APPLICATION FOR SOIL INVESTIGATION

APPENDIX II
SITE EVALUATION

SITE INVESTIGATION REPORT
INDIVIDUAL SEPTIC TANK SYSTEM
WITH SUBSURFACE,
SOIL ABSORPTION,
EFFLUENT DISCHARGE

SIR.NO. 16268
T.C.NO 049-083-14
MAP DATE
DATE Nov. 14, 1979

* See Diagram on Back (Include: Soil areas, property lines, roads, streams, gullies wet areas, fill areas, wells, water bodies, slope patterns, etc

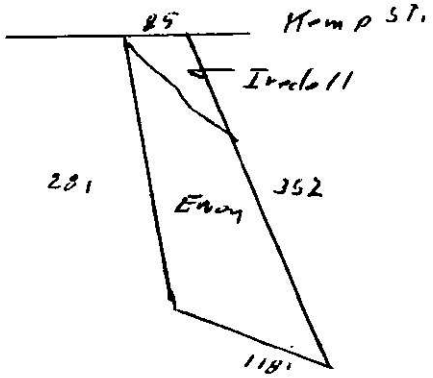
FACTORS	AREA 1	AREA 2	AREA 3	AREA 4
1. SLOPE (%)	(S) PS U 2-8%	(S) PS U 2-10%	S PS U	S PS U
2. SOIL TEXTURE (12-36 in.) (Sandy, loamy, clayey, Note 2:1 Clay)	S PS (U) 2-1 clay	S PS (U) 2-1 clay	S PS U	S PS U
3. SOIL STRUCTURE (12-36 in.) (Clayey Soils)	S PS (U) Massive	S PS (U) weak blocky	S PS U	S PS U
4. SOIL DEPTH (In.)	S PS (U) 48"	S PS (U) 48"	S PS U	S PS U
5. RESTRICTIVE HORIZONS (In.) (Impervious Strata Rock)	(S) None PS U	(S) None PS U	S PS U	S PS U
6. SOIL DRAINAGE/GROUNDWATER (External & internal)	(S) 76" To ground water PS U	(S) 76" To ground water PS U	S PS U	S PS U
7. SOIL PERMEABILITY (Percolation Rate)	S PS (U) V. Slow	S ~~PS~~ Slow → V. Slow U	S PS U	S PS U
8. OTHER (Specify)	S PS U	S PS U	S PS U	S PS U
9. SITE CLASSIFICATION	unsuitable	unsuitable		
SOIL SERIES	Iredell	Enon

Soil Structure Massive
Soil Permeability Unsuitable

Sites classified as Unsuitable are not acceptable for soil absorption of sewage effluent. However, if engineering, geologic, soil, and environmental studies indicate that a suitable septic tank system or a suitable alternate system can be expected to function satisfactorily, such sites may be re-classified as Provisionally Suitable. (Section 10 of the North Carolina Administrative Code 10 A,.1910)

If you desire to file for permission to install an "alternate or modified" system, you should present this office with your proposals in the form of plans and specifications. These would be reviewed and if it is found that the system may reasonably be expected to function satisfactorily, approval may be given on the execution by you of a "Septic Tank Agreement Form" available in this office.
